SERVICE BULLETIN

NUMBER: 15-314-23

SUBJECT: Apple CarPlay & Android Auto application performance & possible no USB power with Gen 3.1 Harman Head Unit -Auxiliary USB Terminal / Design Change

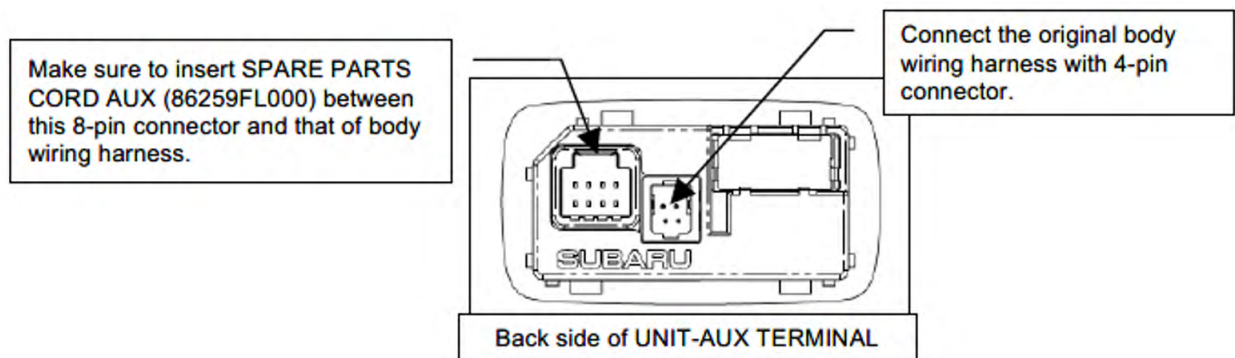
The auxiliary USB terminal and adapter cord have been modified to secure stable connection for the USB port. The Head Unit software is optimized to reestablish the connection, even if it has been interrupted for any reason. If Apple CarPlay or Android Auto connection problem is reported, update the Head Unit with the latest software version per **TSB 15-236-18R** and replace the auxiliary USB terminal with new part in conjunction with the adapter cord. The adapter cord **MUST** be replaced when a new auxiliary USB terminal is installed (Except for BRZ models).

STEP 2: Insert adapter cord (86259FL000) between the original body wiring harness (with 8-pin connector) and the new auxiliary USB terminal as the pin location on the new terminal is different from the original one. The original body wiring harness with 4-pin connector can be used without adapter cord.
